Barnet Local Plan Examination in Public Transport for London (Spatial Planning) – Matter 6 Written Statement

Figure 1 - Map showing town centres in relation to TLRN (red), SRN (purple), rail network and Green Belt. Top left: Historic OS map of Edgware, 1920.

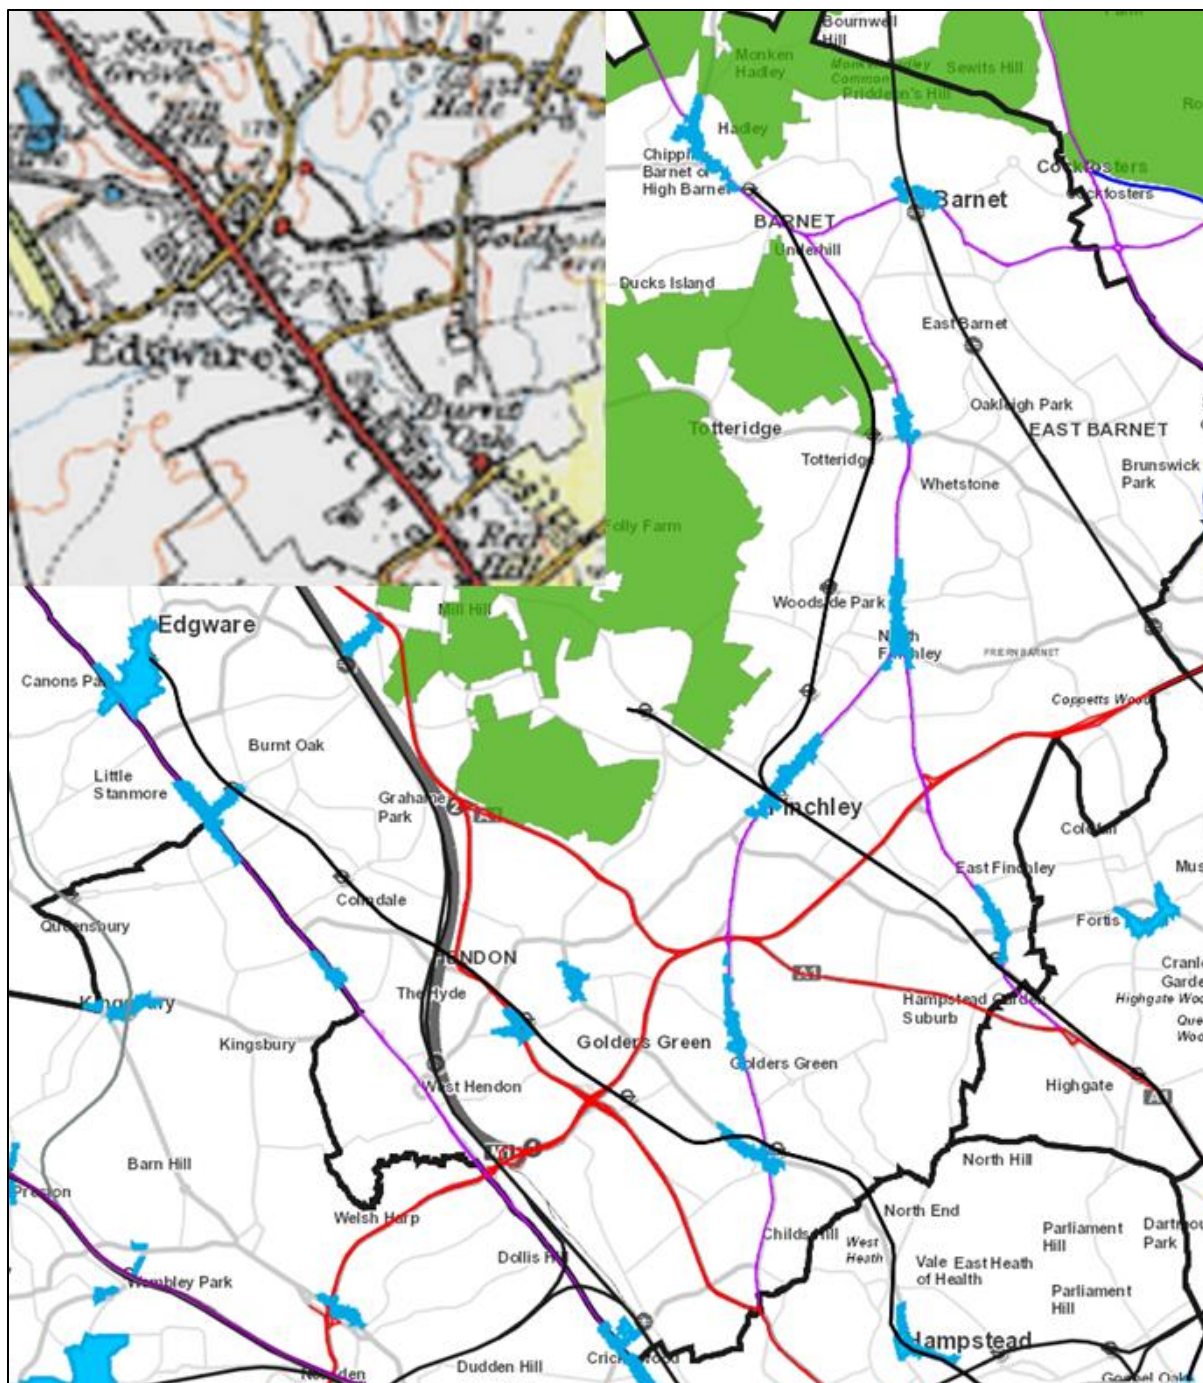
27. The measure does not account for historical patterns of development in Barnet where towns developed along radial roads and railways. Today, most town centres are oriented along these radial corridors with few exceptions. Of the 15 major and district town centres in Barnet, 13 are radially-oriented including Edgware which initially developed along Edgware High Street before developing east along Station Road. While local centres are less likely to be radially-oriented due to their local nature, some local centres are still located along key radial corridors. This results in many local connections being along radial corridors, along which many buses travel. The road network in Barnet is now relatively fixed with few orbital strategic roads (see Figure 1). Indeed, the only orbital road on the TLRN or SRN is the A406.

Figure 2 - Map of the bus network in Barnet.

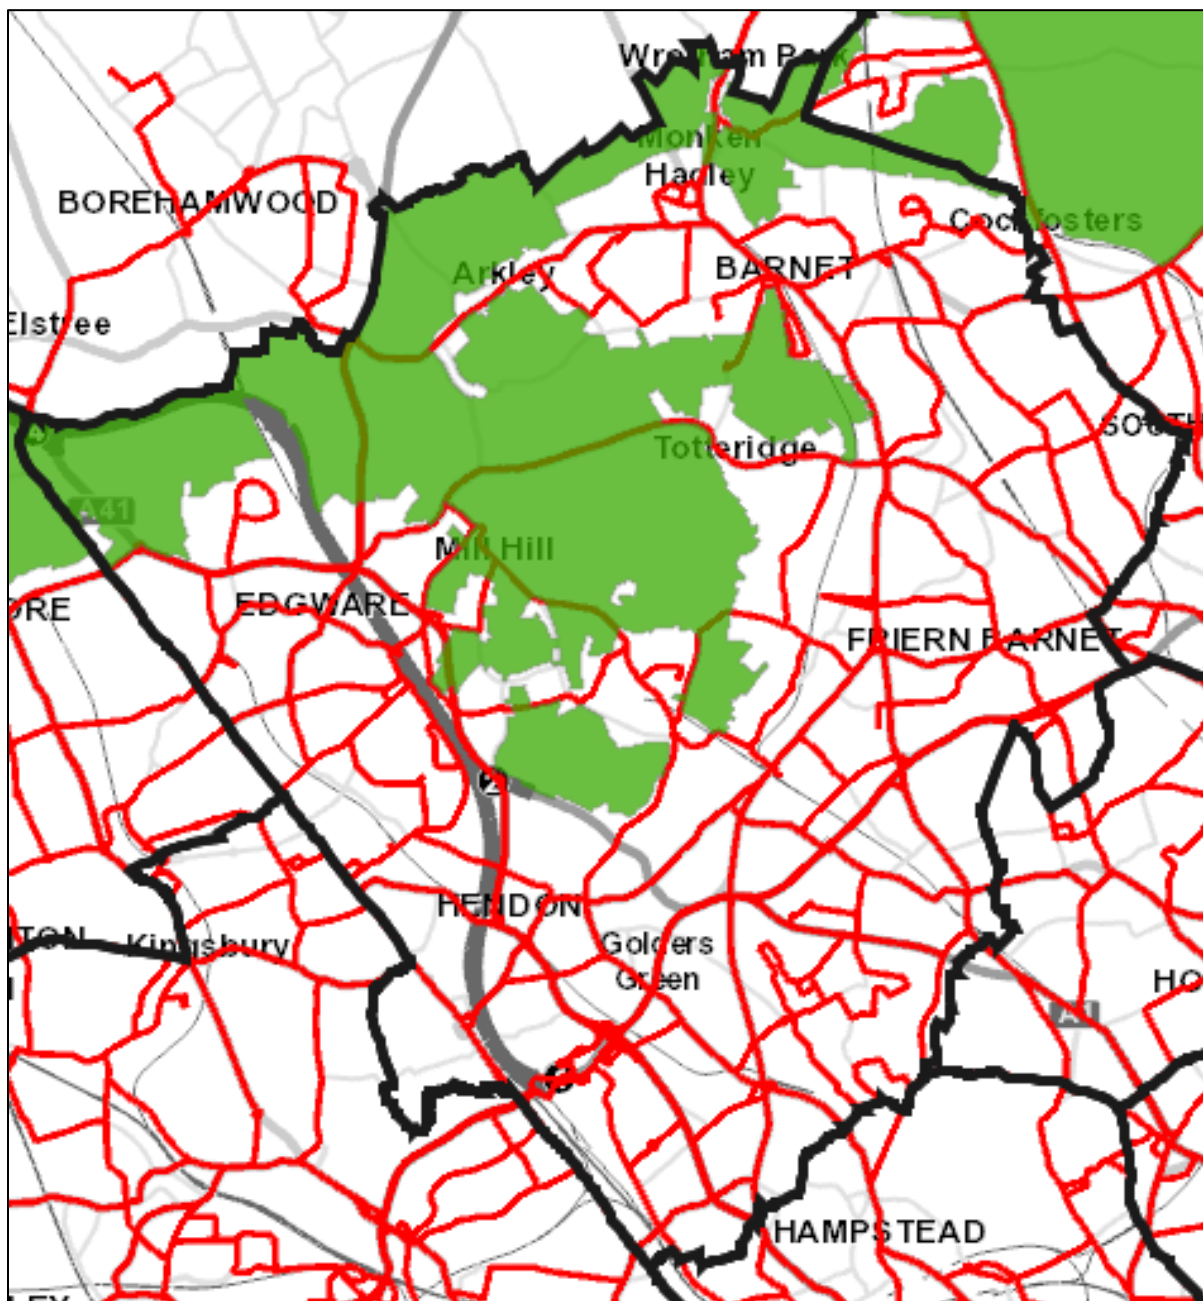
29. Figure 2 shows the bus network in Barnet. The number of passenger kilometres travelled tends to be higher along radial corridors (Figure 4). With most bus journeys originating in Barnet, also ending in Barnet, this does not represent people going into central London. While one of the justifications

Figure 3 - Average bus speeds in Barnet (mph)

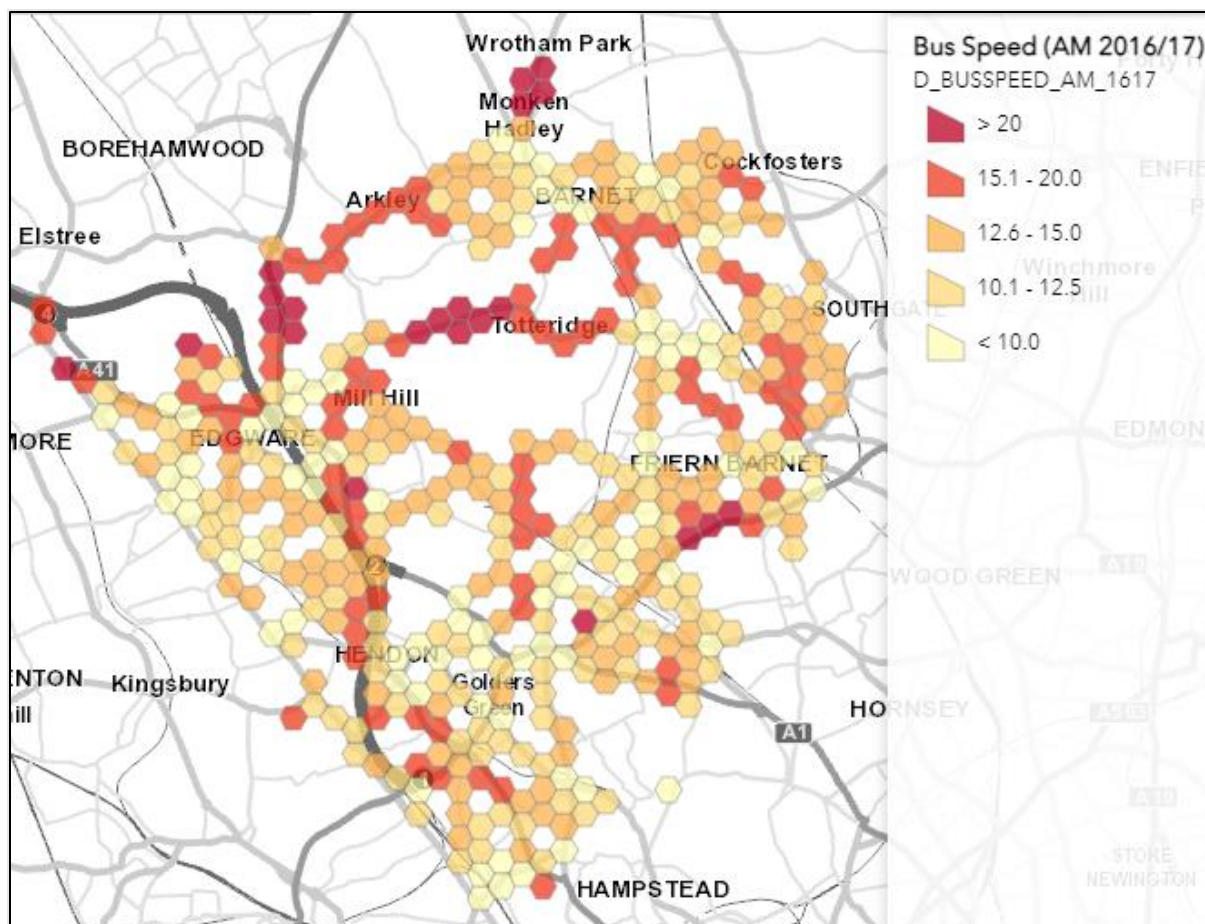
given by the Council for an orbital access measure is slow journey times, buses actually tend to operate at higher average speeds along orbital rather than radial corridors (Figure 3). The higher demand on existing radial rather than orbital routes may be partly attributable to higher frequencies but could equally be related to the density of key destinations along these corridors.

Figure 5 - Scheduled bus kilometres AM peak

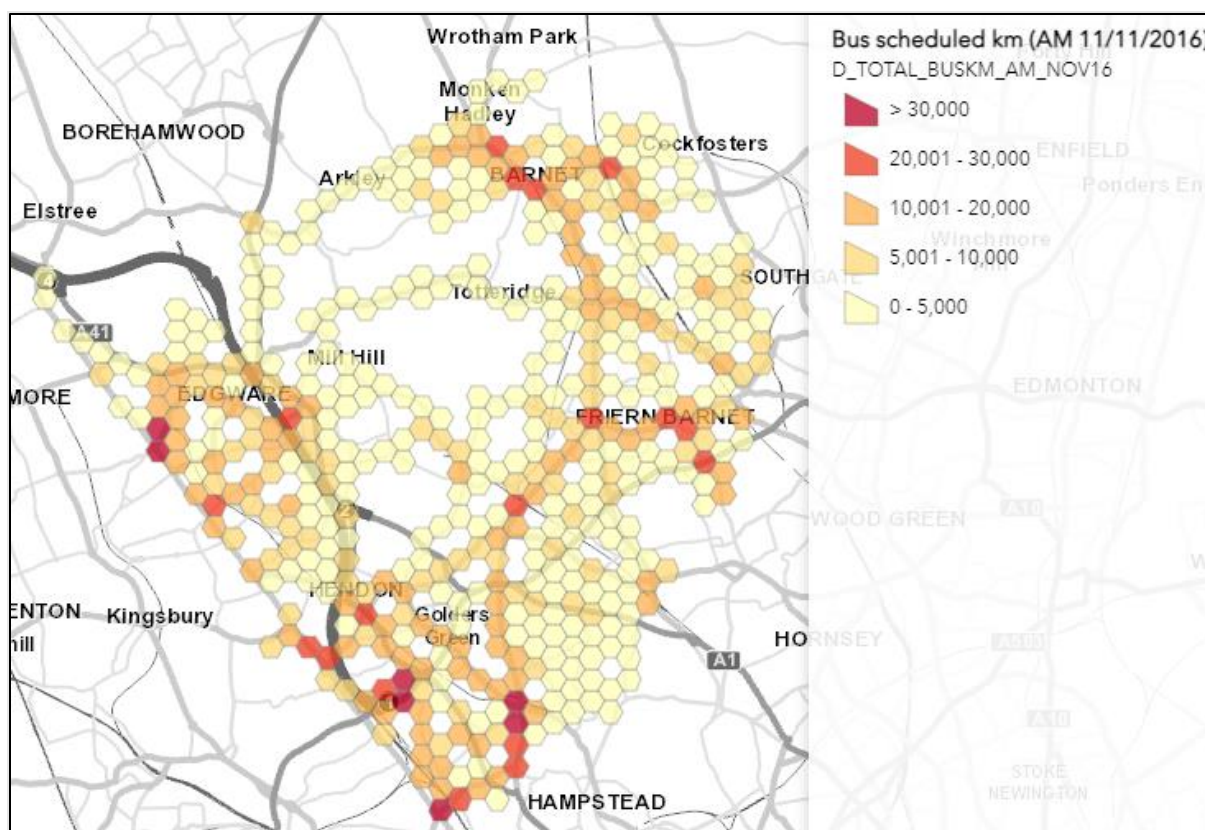
31. It is notable that there is a higher level of bus provision in town centres relative to demand (Figure 5), with the network oriented to provide access to town centres (and transport hubs) from a wide range of areas, meaning, in turn, that future residents within these hub locations will be able to easily access most places in the borough without a car.
